**LEE C. FINE MEMORIAL AIRPORT
CITY OF OSAGE BEACH, MISSOURI**

ADDENDUM NO. 2

State Project No. 17-046B-1

**RECONSTRUCTION OF TAXIWAY A (NEW TAXIWAY A AND A1) FROM
TAXIWAY C TO RUNWAY 22 END**

FILE:	
DESIGN BY:	MND
DRAWN BY:	JRO
CHECKED BY:	MND
APPROVED BY:	BHH
DATE:	APRIL 9, 2018
JOB No:	17486-02
DEMOLITION PLAN SHEET 1 OF 3	
SHEET 15 OF 52 SHEETS

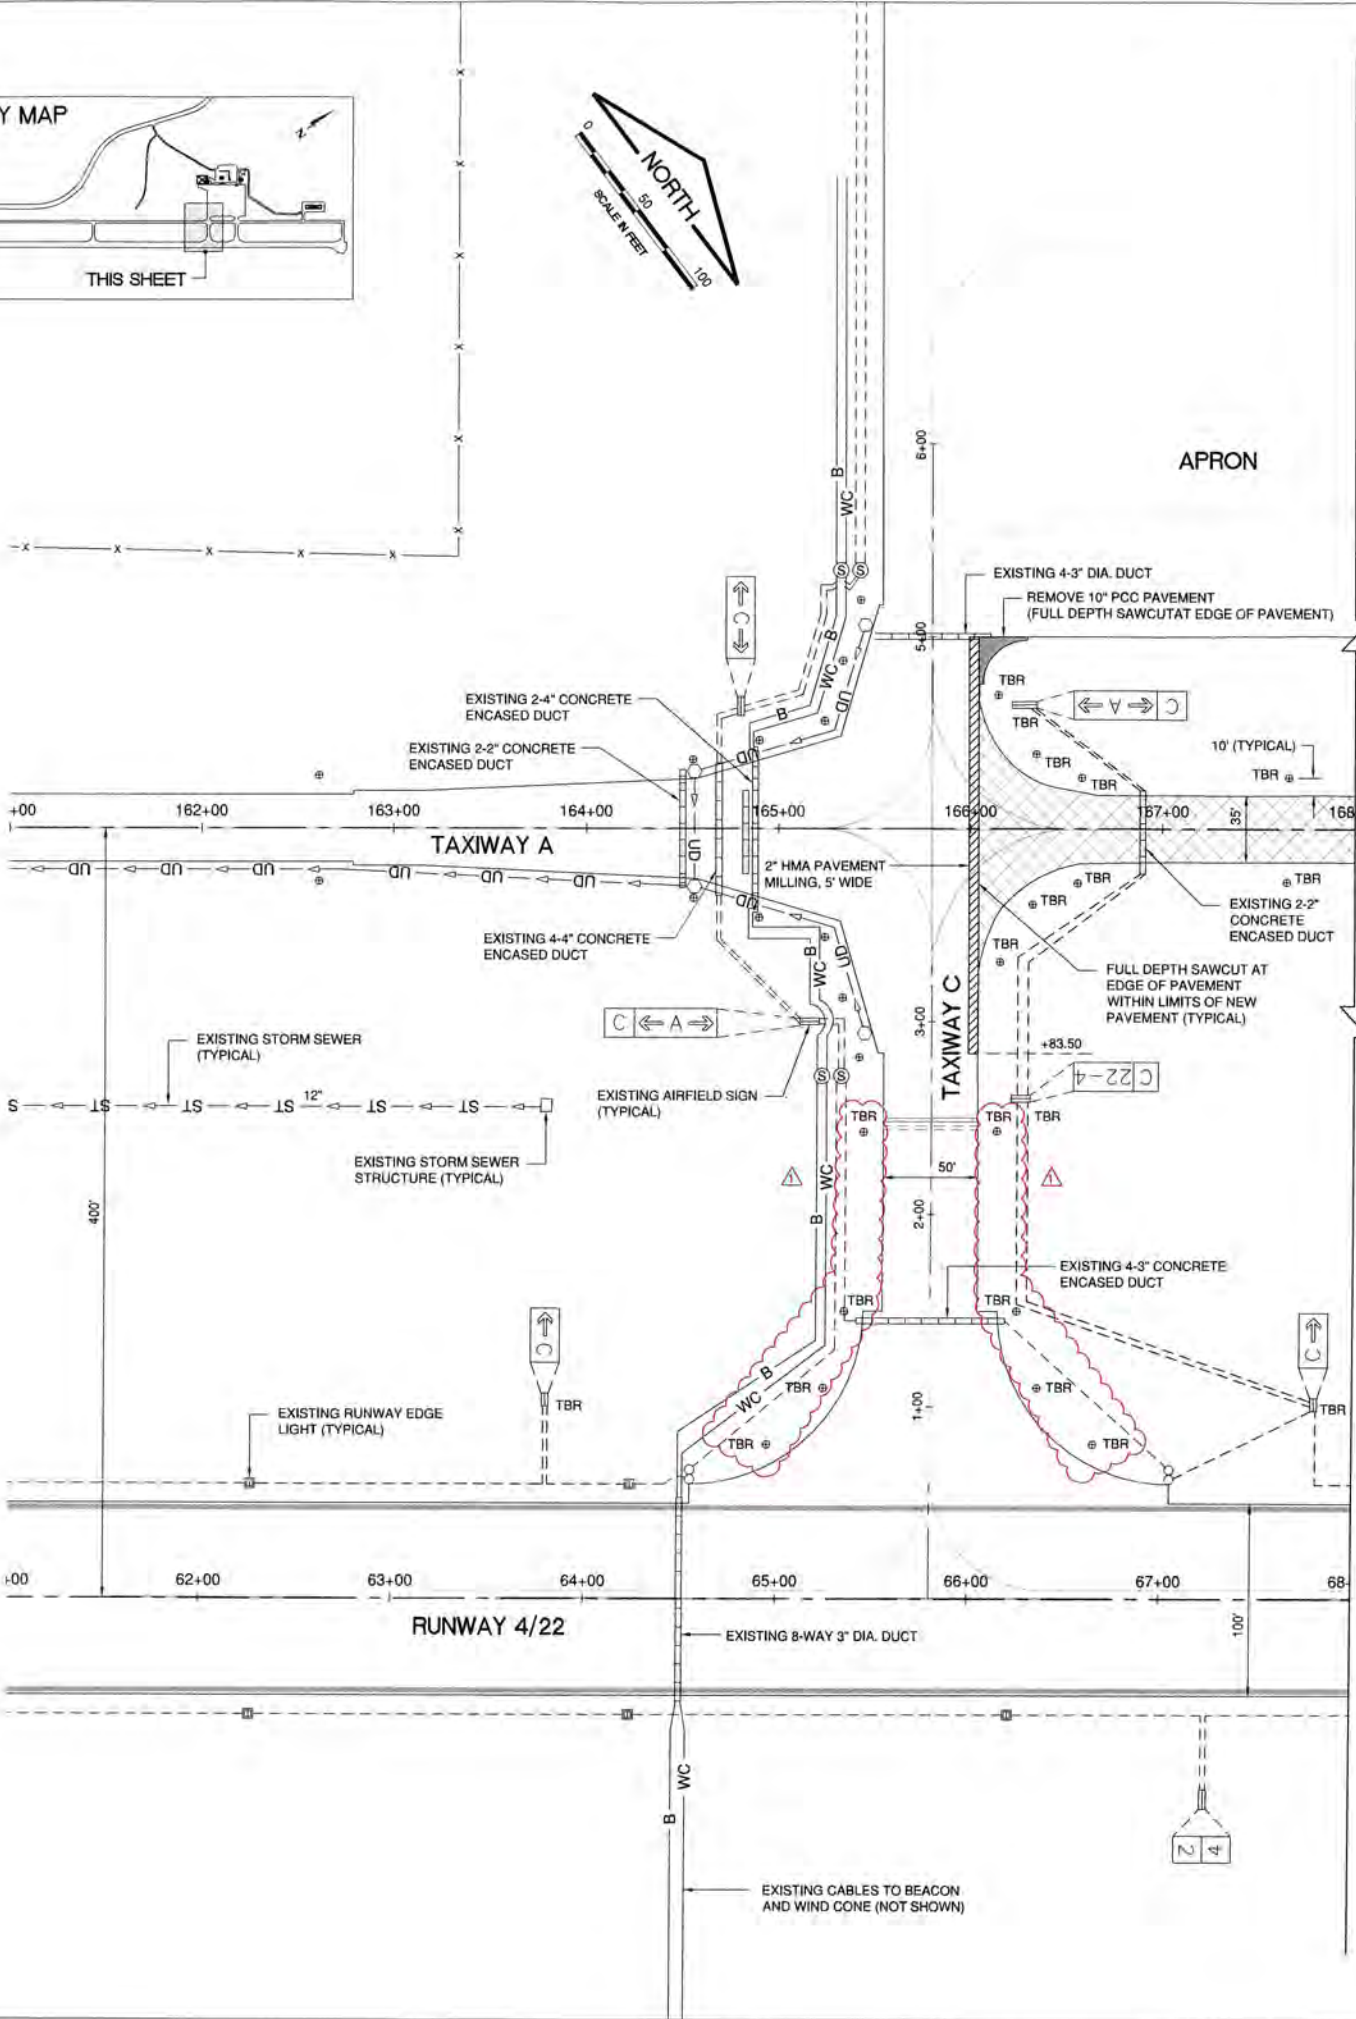
SHEET 15 of 52 – Demolition Plan Sheet 1 of 3

DELETE: This sheet.

ADD: Attached sheet.

CLARIFICATION: Revised sheet shows additional locations of existing taxiway edge markers to be removed adjacent to Taxiway B.

FILE:	
DESIGN BY:	MND
DRAWN BY:	JRO
CHECKED BY:	MND
APPROVED BY:	BHH
DATE:	APRIL 9, 2018
JOB No:	17486-02
DEMOLITION PLAN SHEET 2 OF 3	
SHEET 16 OF 52 SHEETS

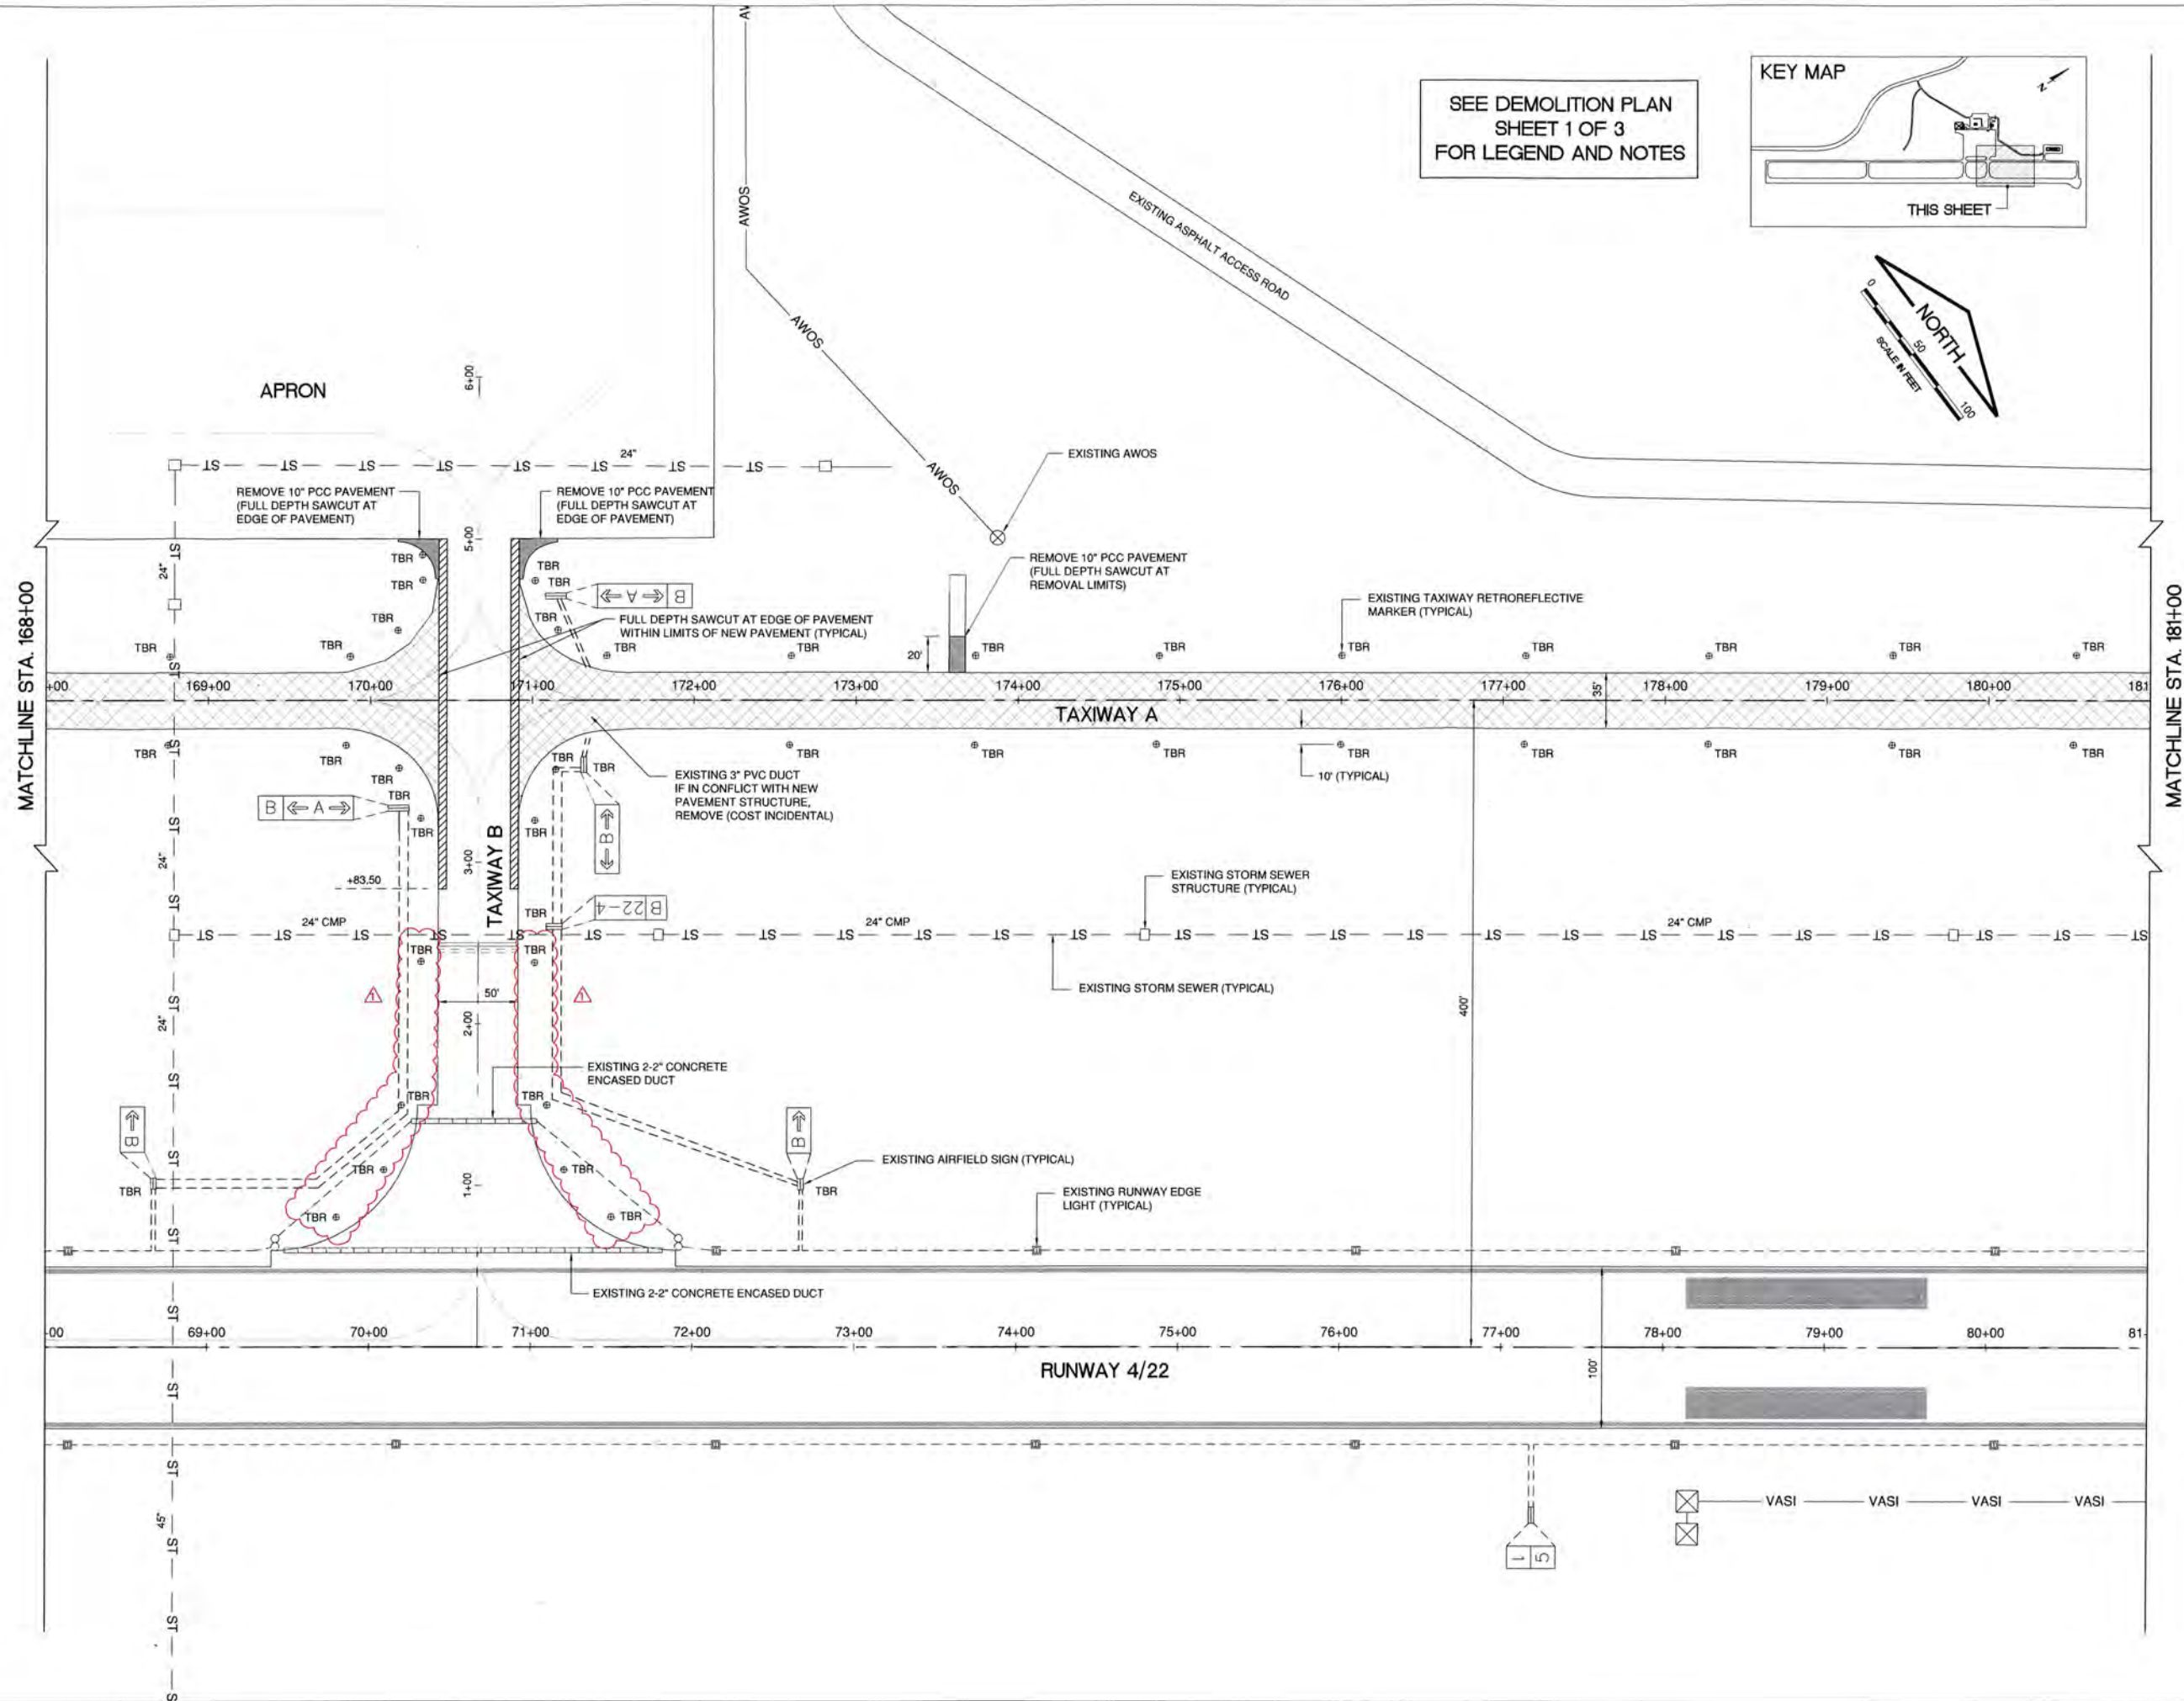
SHEET 16 of 52 – Demolition Plan Sheet 2 of 3

DELETE: This sheet.

ADD: Attached sheet.

CLARIFICATION: Revised sheet shows additional locations of existing taxiway edge markers to be removed adjacent to Taxiway C.

FILE:	
DESIGN BY:	MND
DRAWN BY:	JRO
CHECKED BY:	MND
APPROVED BY:	BHH
DATE:	APRIL 9, 2018
JOB No:	17486-02
MARKING AND ELECTRICAL PLAN SHEET 1 OF 2	
SHEET	34 OF 52 SHEETS

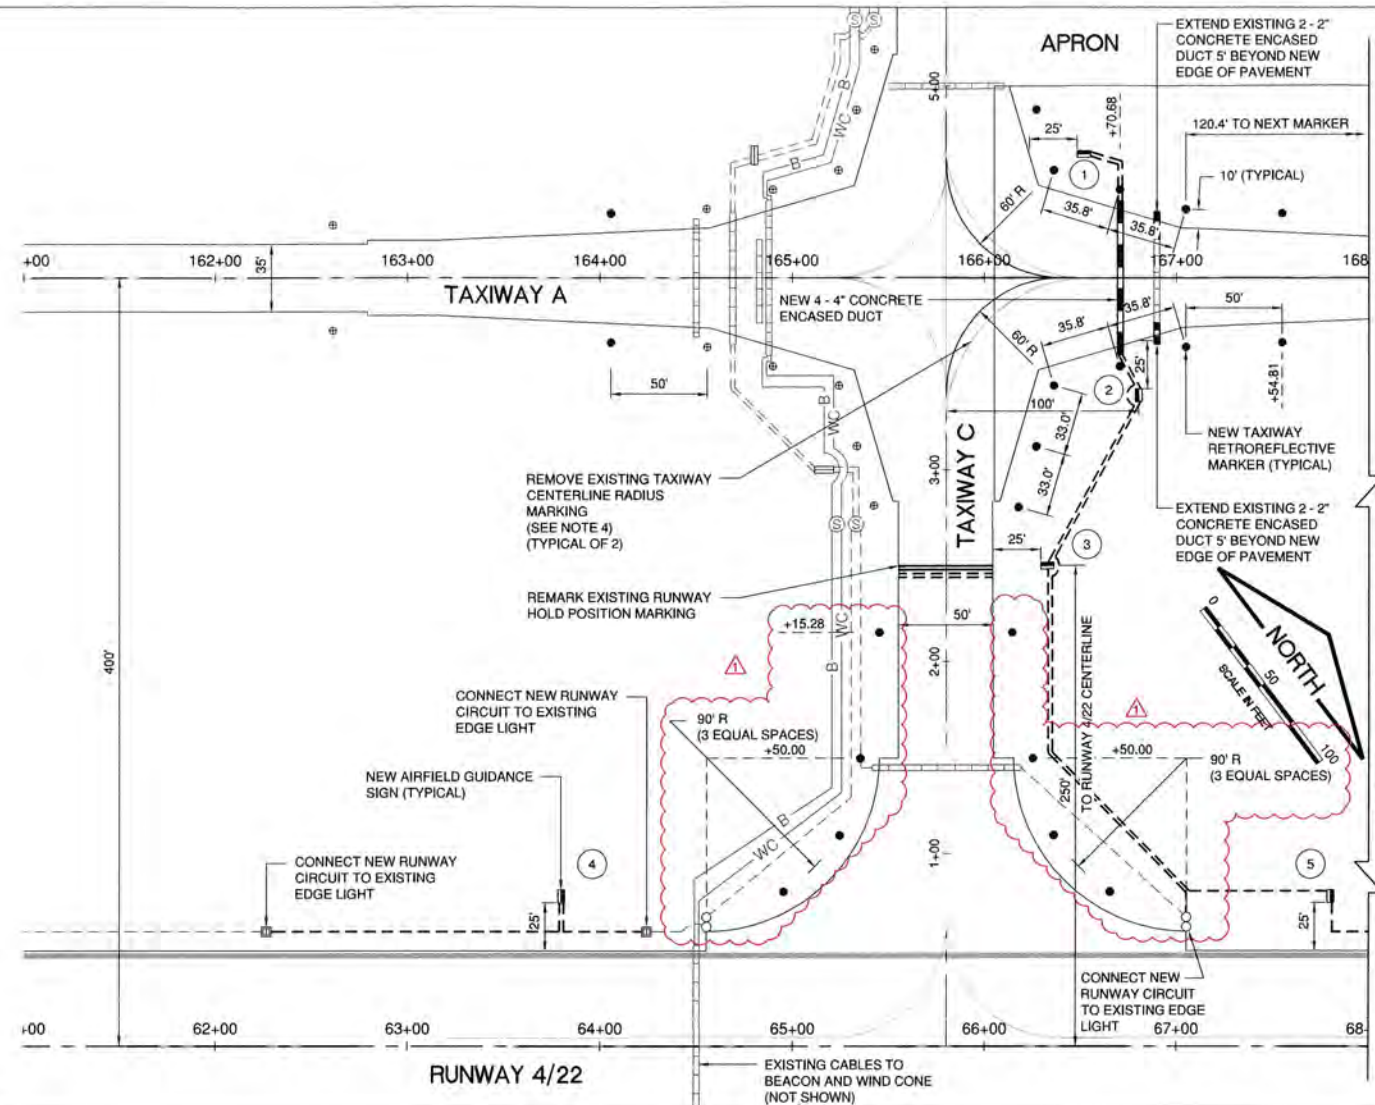
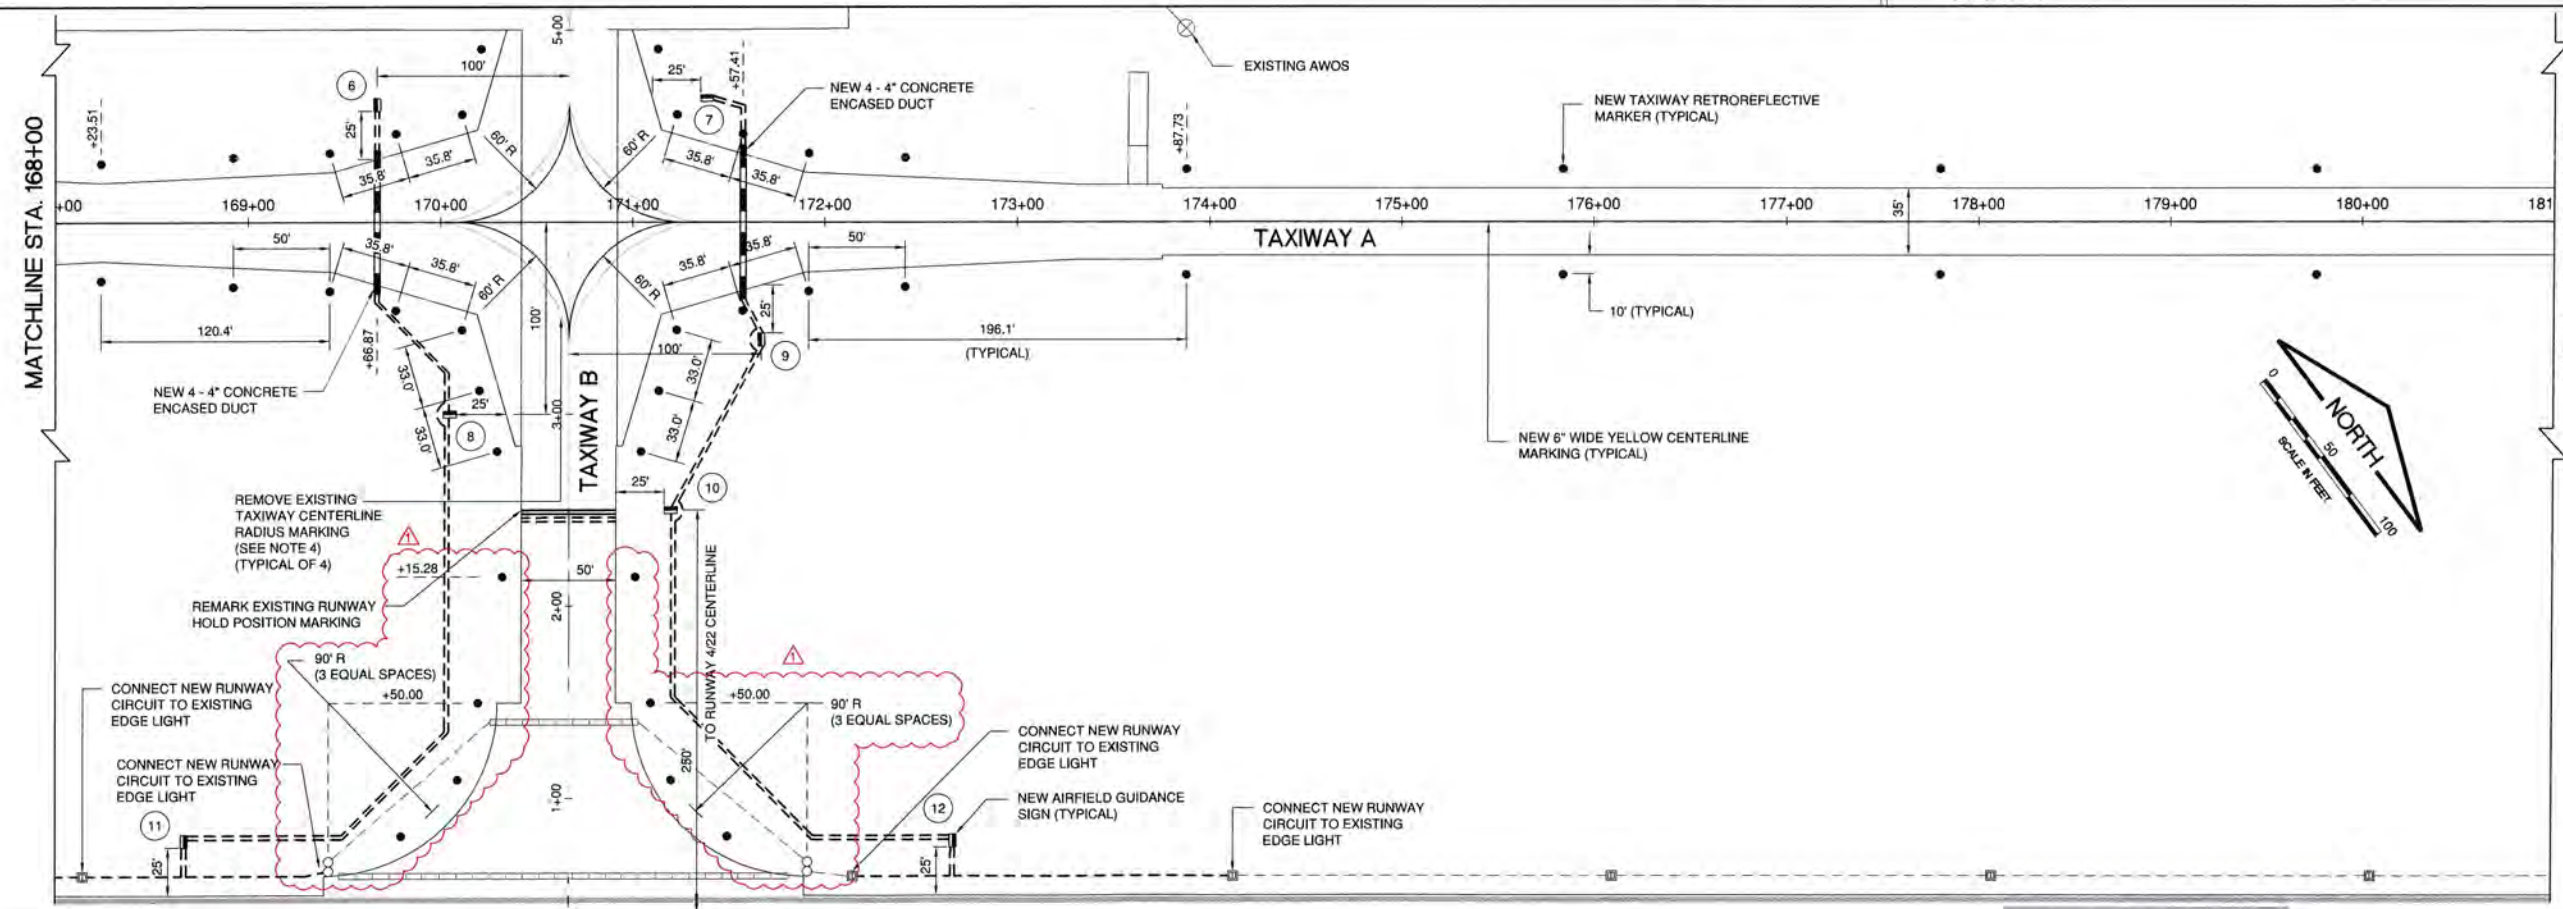
SHEET 34 of 52 – Marking and Electrical Plan Sheet 1 of 2

DELETE: This sheet.

ADD: Attached sheet.

CLARIFICATION: Revised sheet shows additional locations of new taxiway edge markers to be installed adjacent to Taxiway B and Taxiway C.
